PERFORMANCE SPECIFICATION SHEET
MICROPHONE AND MICROPHONE ASSEMBLY, DYNAMIC,
M-116()/G AND M26542/8-01

This amendment forms part of MIL-PRF-26542/8B, dated 30 May 1997, and is approved
 for use by all Departments and Agencies of the Department of Defense.

MIL-PRF-26542/8B
AMENDMENT 1

FIGURE 4. Frequency response.

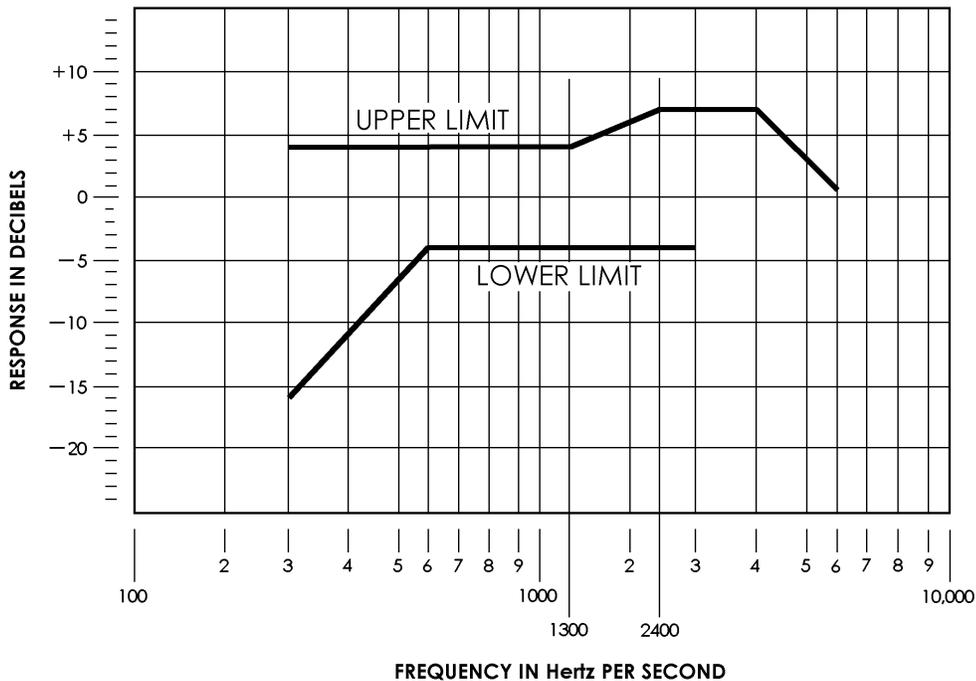
Figure 4: Delete and substitute:

Frequency response envelope: Add the following:

Frequency points	300 Hz	600 Hz	1,300 Hz	2,400 Hz	3,000 Hz	4,000 Hz	6,000 Hz
Upper limits (dB)	+4.0	+4.0	+4.0	+7.0	+7.0	+7.0	+1.0
Lower limits(dB)	-16.0	-4.0	-4.0	-4.0	-4.0	-----	-----

The response curves generated shall be on the same scale as shown on figure 4. The response curve shall not exceed the upper and lower limit curves of the stationary frequency response envelope, within the frequency ranges identified in the appropriate chart (see figure 4).
